UNITED STATES  
NUCLEAR REGULATORY COMMISSION  
WASHINGTON, D. C. 20555

PALISADES PLANT

AMENDMENT TO PROVISIONAL OPERATING LICENSE

Amendment No. 43  
License No. DPR-20

Figure 3-9

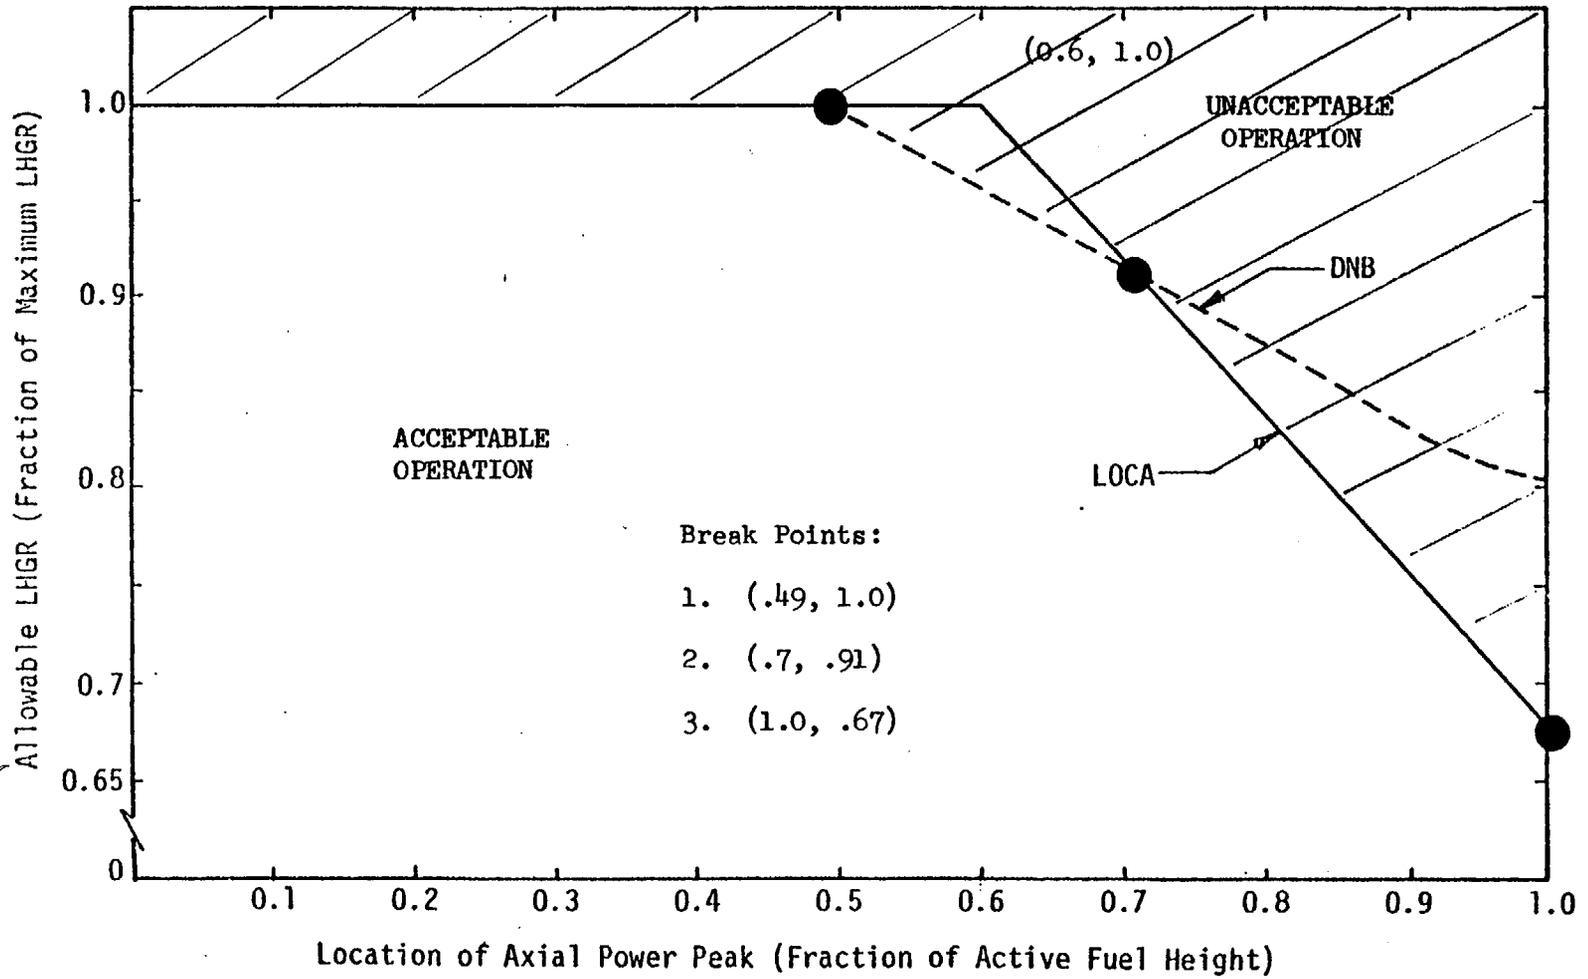
where the function  $F_A(z)$  is shown in Figure 3.9. If the power distribution is double peaked, both peaks shall satisfy the criterion.

- 6.7 Figures 3-7 and 3.8 have been deleted because they no longer required in view of the Technical Specification changes discussed herein. Figure 3.9 has been replaced with the correct function supported by the change discussed in Section 6.3.1 above.

- 6.3 Two changes have been made in Section 3.10.3.2 as follows:
- 6.3.1 The linear heat generation rate (LHGR) limit has been increased to  $15.28 \text{ KW/ft} \times F_A(Z)$  for ENC fuel and to  $14.12 \text{ KW/ft} \times F_A(Z)$  for D type fuel, where the  $F_A(Z)$  function is an axial shaping function. This function is shown in Figure 3.9 of the Technical Specifications. These KW/ft limits and the new  $F_A(Z)$  function are the primary subject of this Technical Specification change request, and are acceptable for the reasons provided under the discussions of Thermal and Hydraulic Design, Transient and Accident Analyses, ECCS Performance Evaluation, and Neutronics Analysis.
